Is the Beachen Court Development in the Cairngorms National Park the national “go to” place for water technology?

On 26 April 2018 an Icelandic delegation on a water technology knowledge exchange visit to Scotland visited the SUDS scheme currently being installed on Beachen Court, a housing development under construction in Grantown-on-Spey. A video was posted on the Cairngorms National Park Authority Facebook page on 1 May 2018 ([see here](#)) which portrays this SUDS scheme as best practice but nothing could be further from the truth – instead there are important lessons for CNPA and developers to learn about avoiding the pitfalls into which this scheme has fallen.

Plan1: Design drawing proposing siting the SUDS pond on the 1:4 slope

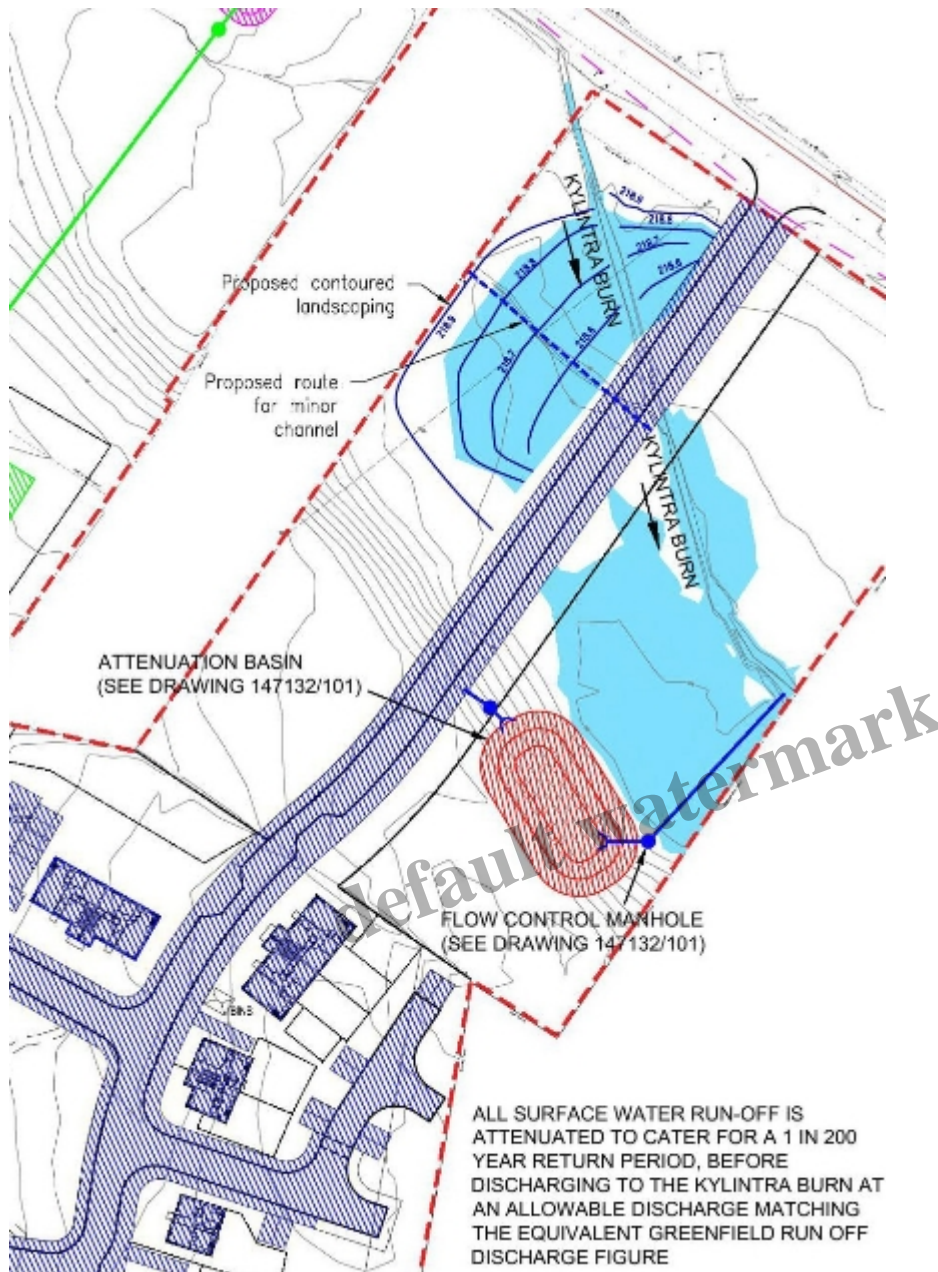
The initial engineering drawing submitted to CNPA around March 2016 in support of the planning application contained several serious design issues e.g. it proposed that a SUDS pond, capacity some 500m³ be located in the middle of the 1:4 slope of river terrace south of the floodplain – a ridiculous proposition:

The dimensions of the proposed pond were also incorrect, far too small to provide the stated design capacity. OK, the design engineer made some dreadful mistakes but, just as concerning, when the developer submitted this drawing in support of his application the CNPA as Planning Authority, apparently without thought, put it out for public consultation. CNPA will say it's not their job to question design when there is a statutory consultee to make comments but the faults with the pond were so obvious it would surely have been common sense for CNPA to address them before consultation and avoid wasting consultees' time.

Plan 2: Approved design for the relocated SUDS pond. Note the constraints of new access road, public road (Seafield Avenue), The Dulaig driveway and the Kylintra Burn floodplain

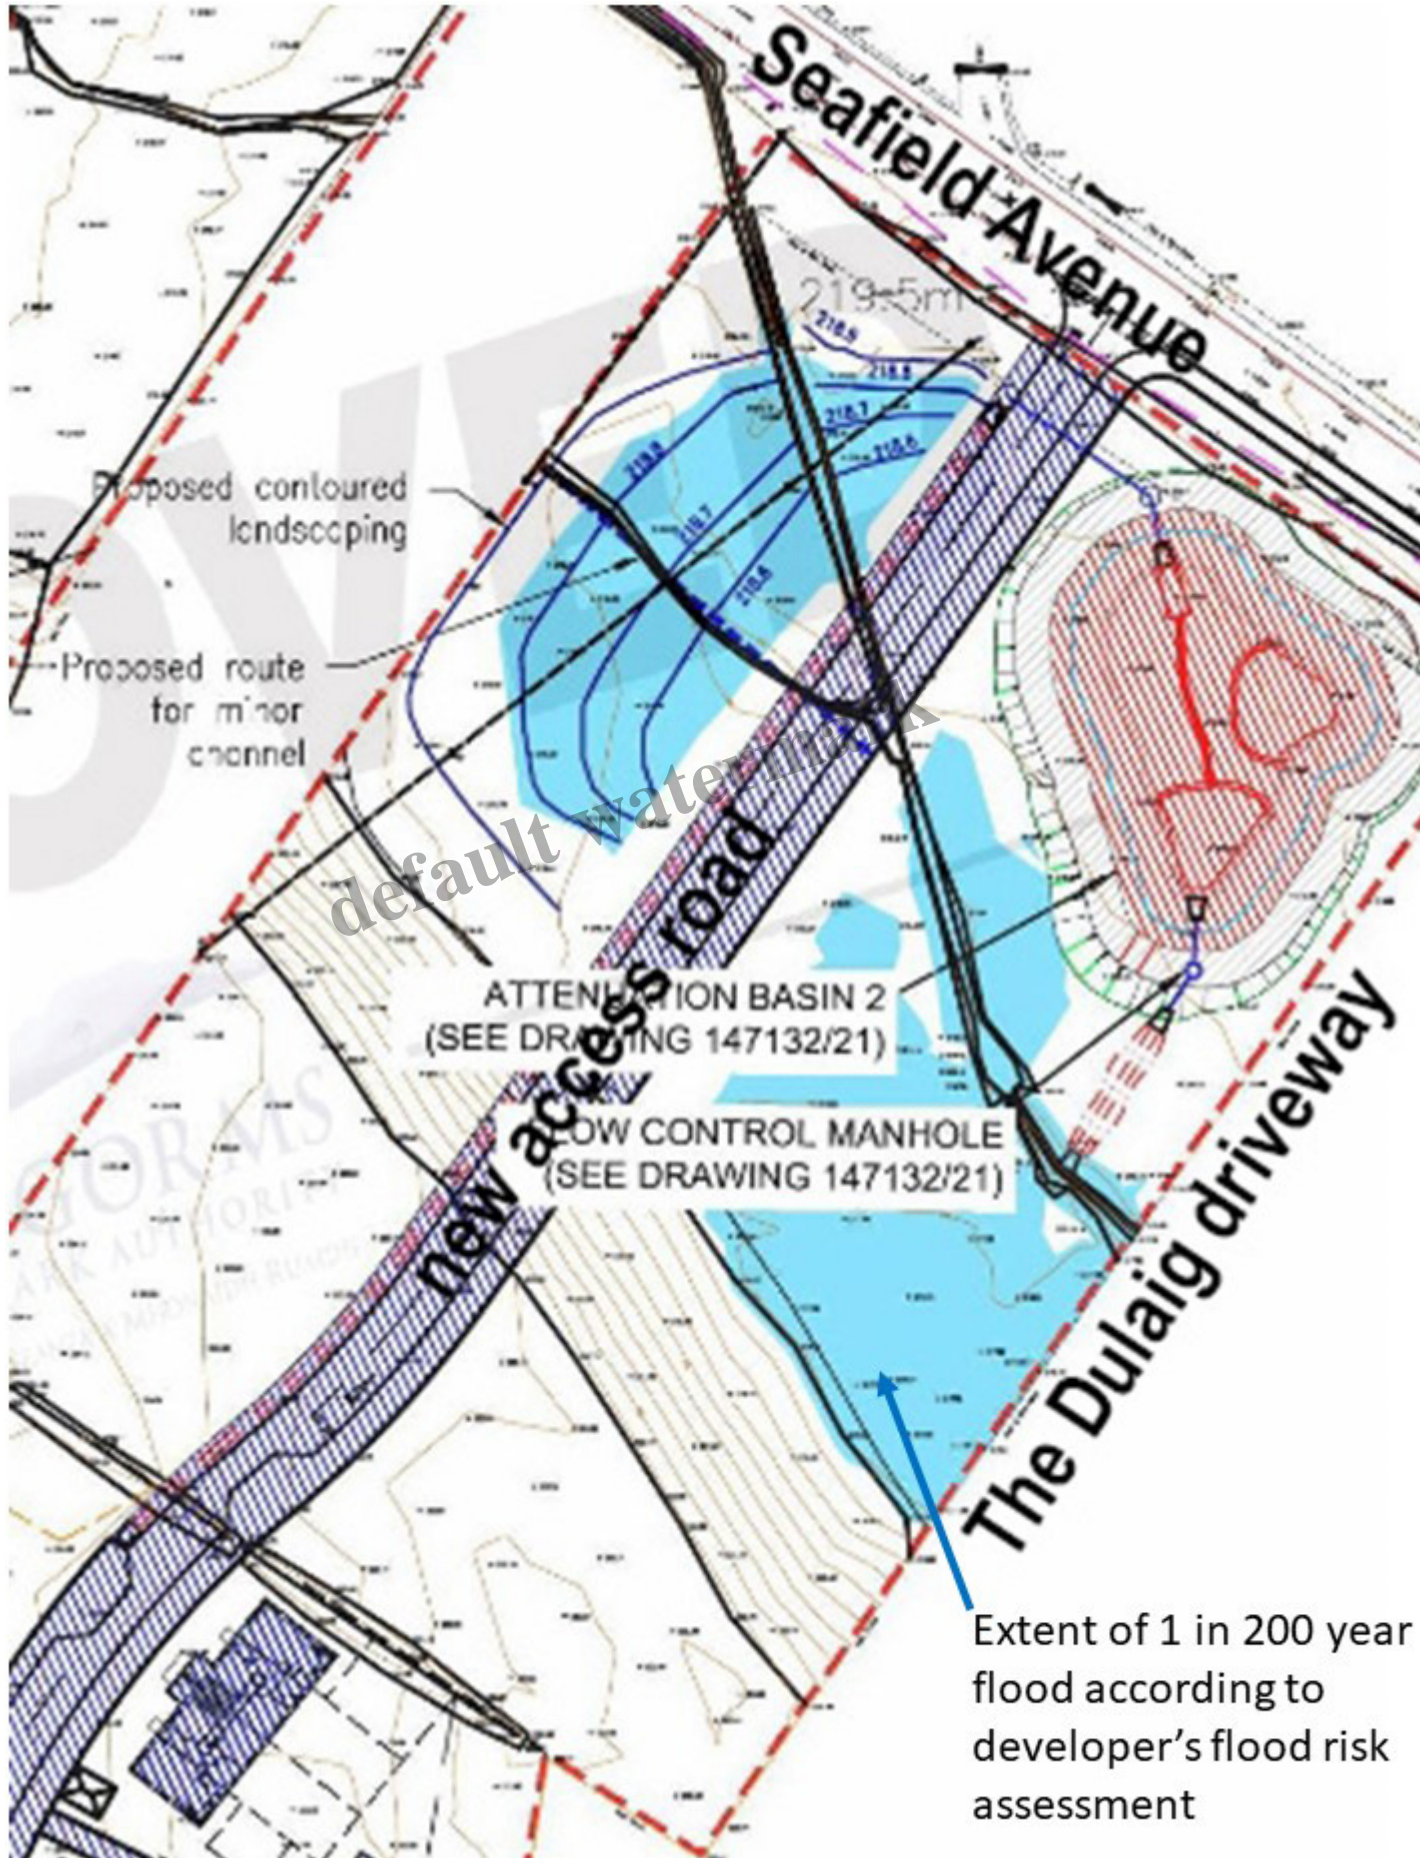
Following criticism on consultation the plan was amended to show the SUDS pond relocated onto the floodplain area of the Kylintra Burn. The size appeared to offer the design capacity and other errors were corrected. Statutory consultees seemed relatively content with the new design which was included in the planning application approved by the CNPA Planning Committee in October 2016, however significant problems remained e.g.:-

– The size and shape of the SUDS pond is highly constrained by the new access road to the west, Seafield Avenue to the north, the driveway of The Dulaig to the east and the flood plain of the Kylintra

Burn to the south. There is no room for manoeuvre.

After planning permission had been granted it was discovered that the approved design completely ignored that the mature trees lining our driveway required a tree root protection area – up to 9 metres wide – which stretched into the development site. The design required the eastern embankment of the pond be built right over this tree root protection area.

Plan 3: Plan showing error in locating the SUDS pond to overlap with the required tree root protection area

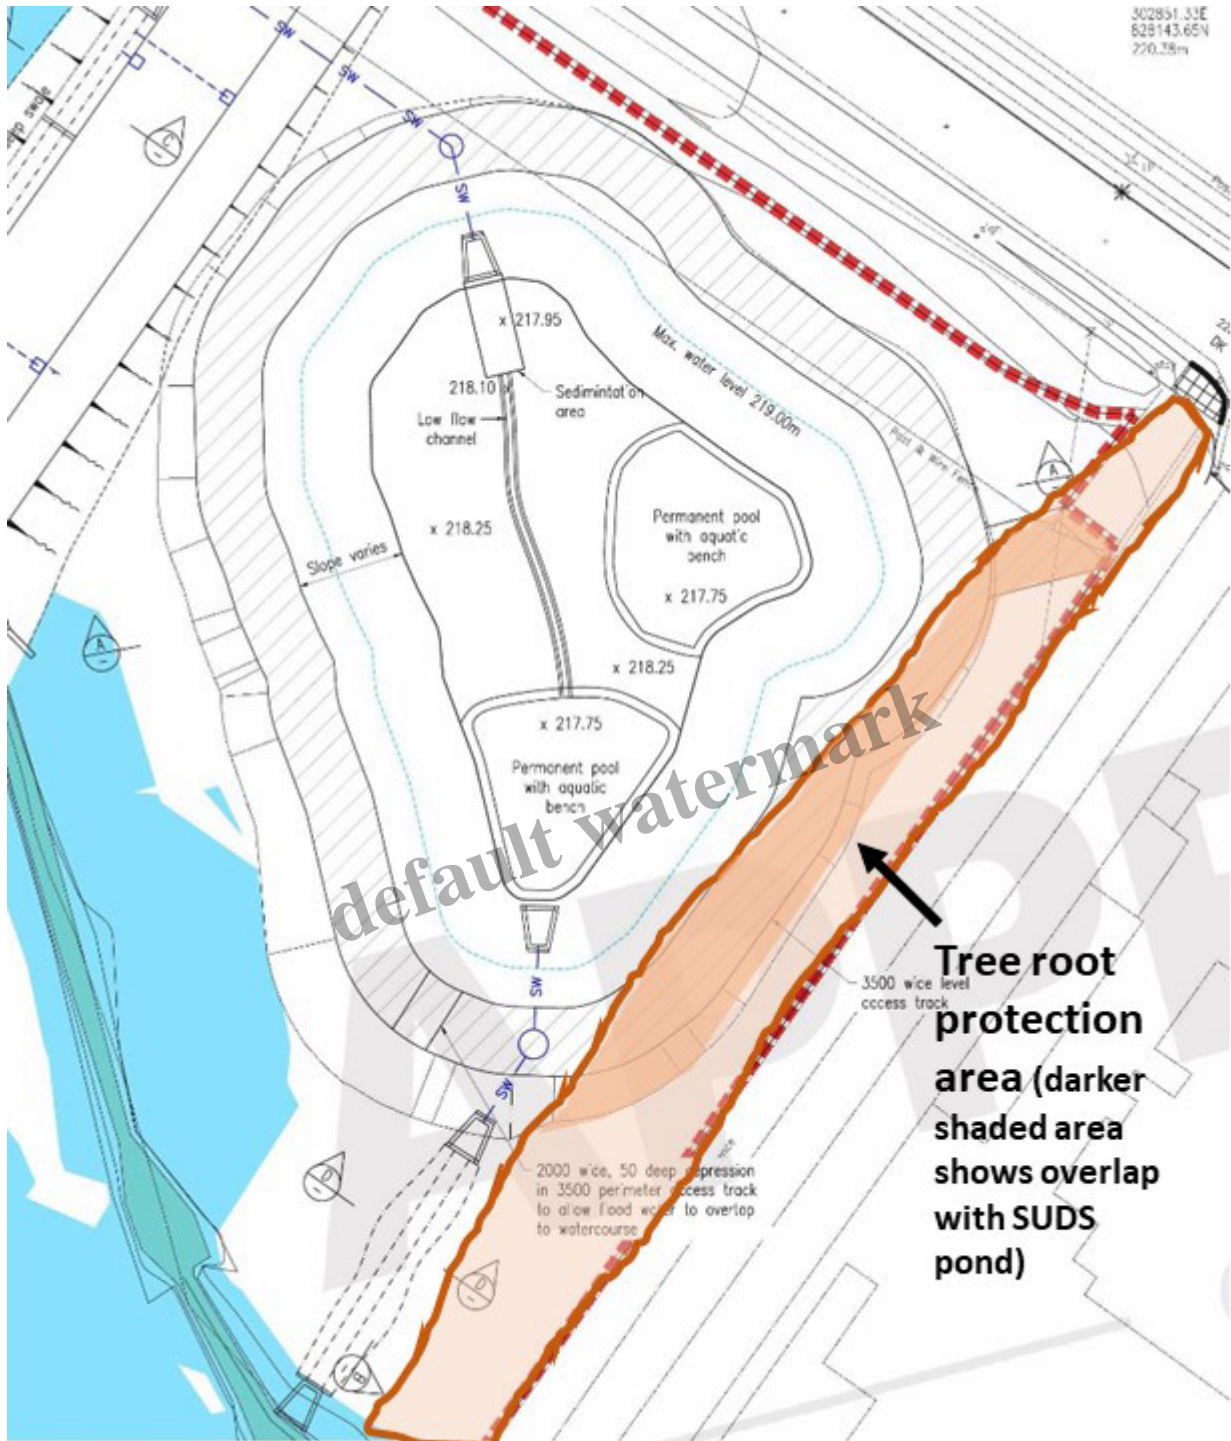
The paper trail is a bit unclear but it appears that CNPA was certainly aware of the tree problem in late April 2017, just as development site work was commencing. Why was this problem not picked up earlier? In my opinion it was due to bad – or non-existent – project management and because the drawing showing the relocated SUDS pond was too schematic i.e. it shows the dimensions of the pond but not its position relative to the surrounding fixed structures. This is a learning point for the planners.

The natural flood plain after a period of heavy rain (Nov.2016).The footprint of the as-built SUDS pond

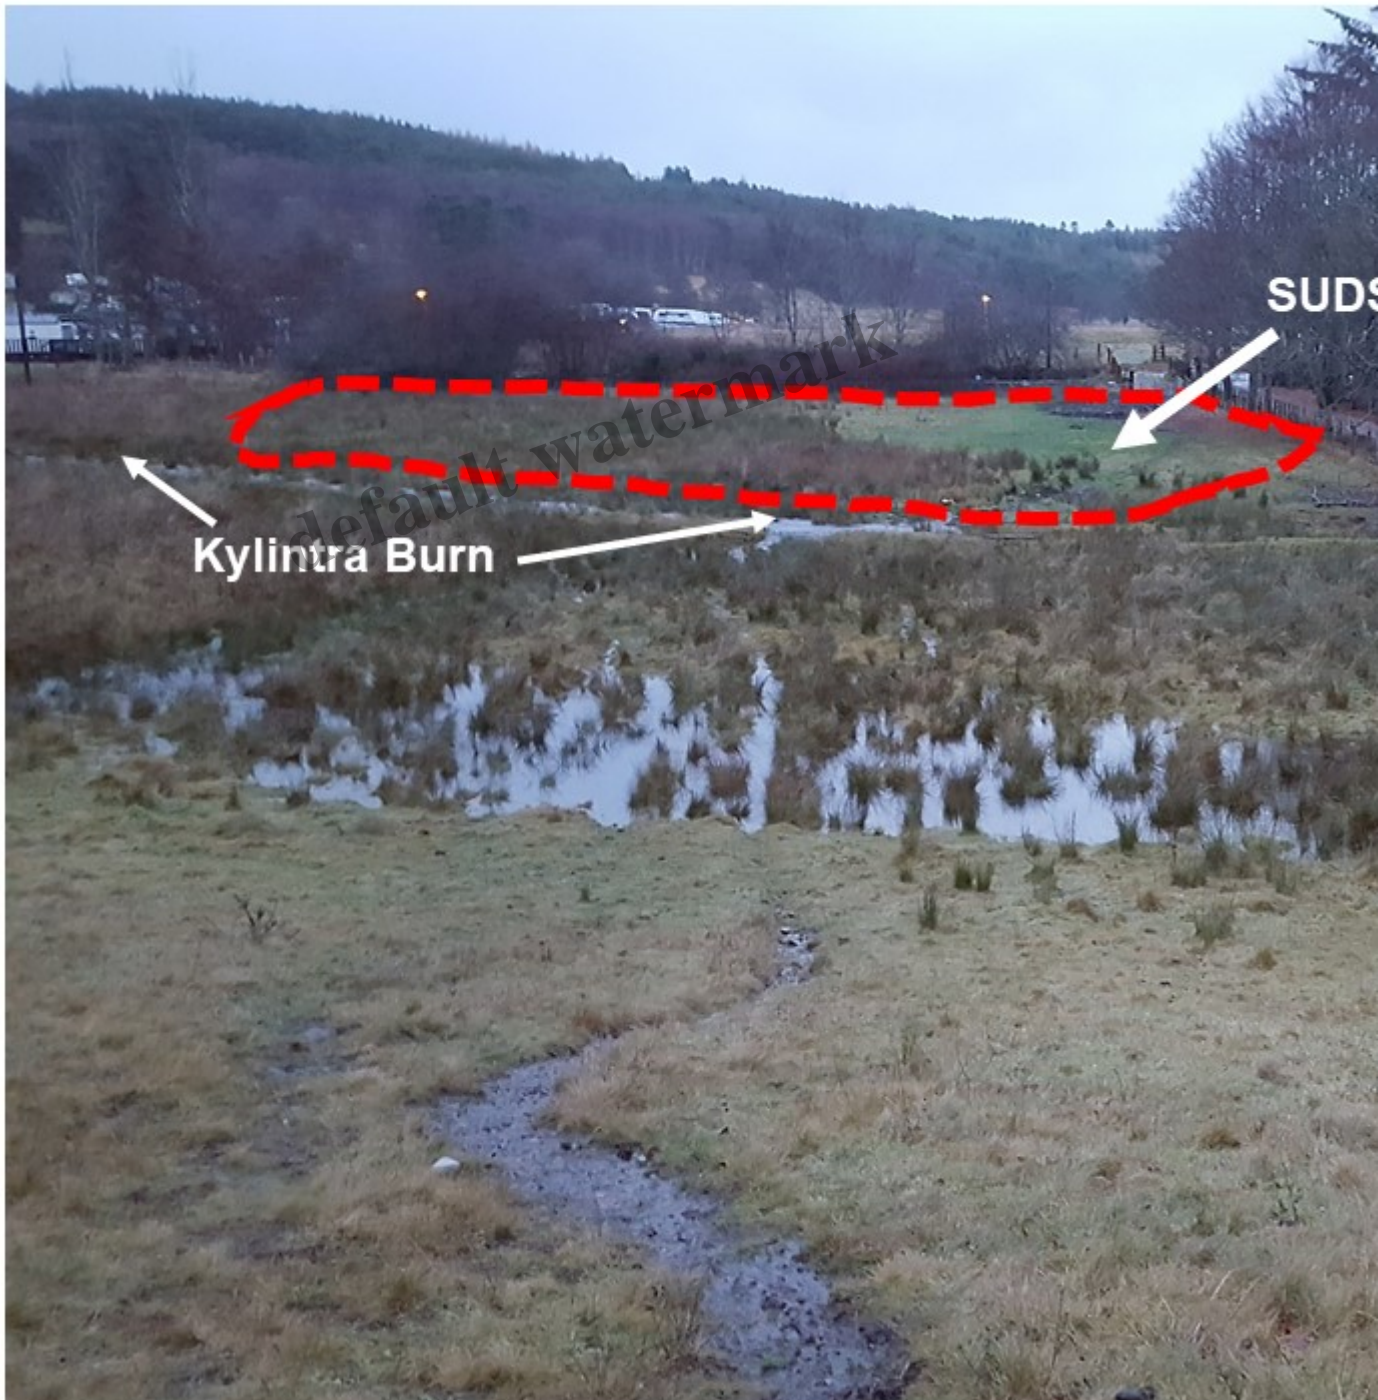
Does the SUDS pond encroach on the area of flood plain required to cope with a 1 in 200 year flood (Plan 2 above)? The Developer's Flood Risk Assessment says it does not, but I have serious doubts about this. In addition I have concerns that the as-built SUDS pond footprint, including embankments, is larger than the approved drawing and thus further encroaches on the already restricted flood plain.

Note that most of the SUDS pond footprint covers an area which had been long grass and rushes – an indicator of wetland – demonstrating it encroaches on the functioning flood plain

Plan 4: The approved SUDS plan overlaid with the additional unapproved fill area shown in photo 5

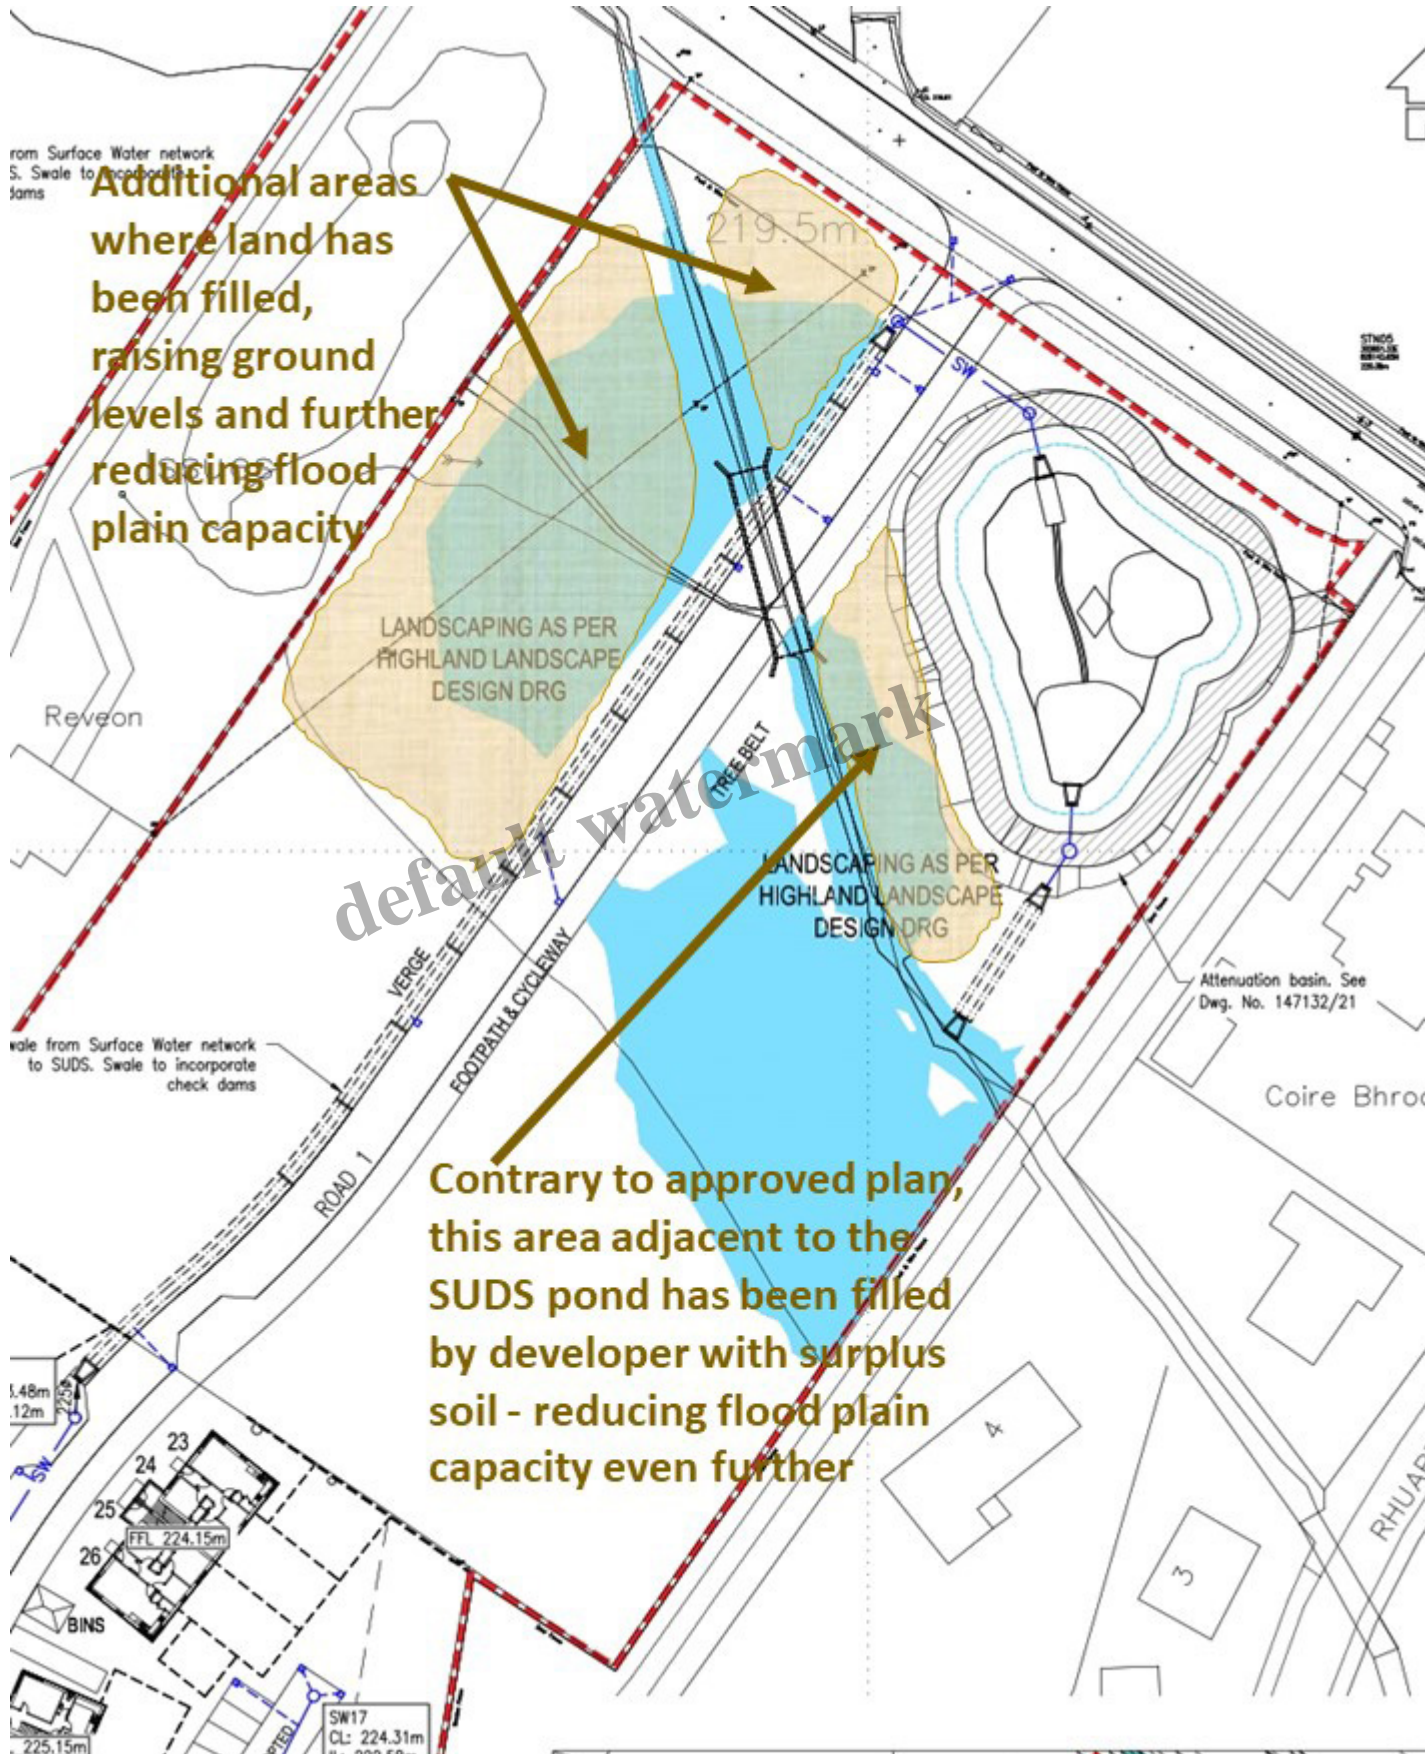
below which further reduces flood plain capacity.

Note too the large areas of flood plain filled in on the opposite side of the new access road (illustrated in photos 10 and 11 below)

Edge of SUDS pond embankment sloping down to the Kylesha Burn. Compare this with Plan 4 which shows there should be at least 10 metres of flood plain between the embankment and the Burn.
